Product / Process Change Notification (PCN)

PCN #: PCN_WCAP-PSHP_20220421

Affected Series: WCAP-PSHP

DESCRIPTION AND PURPOSE OF CHANGE:

Example for drawings with indirect dimensioning

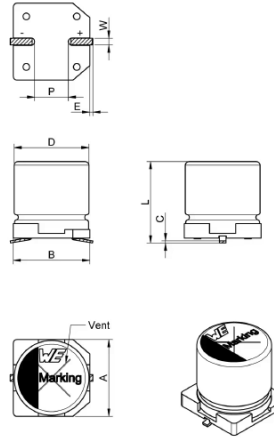
- All corrections in terms of mechanical characteristics are shown. In order to visualize the corrections of the dimensions example of the old and the new drawings is shown below. Würth Elektronik will update the dimensioning from an indirect dimensioning to a direct dimensioning:

Example for new drawings with direct dimensioning

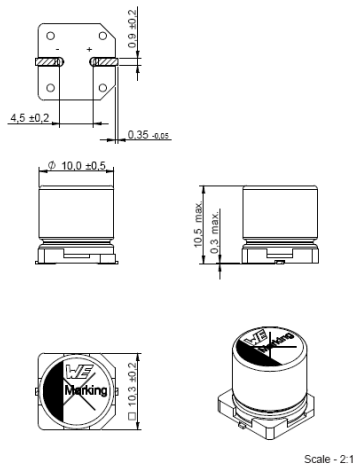
In the course of the update from indirect to direct dimensioning the values for the dimensions and tolerances will be updated. The upcoming corrections can be seen more detailed in the pictures above.
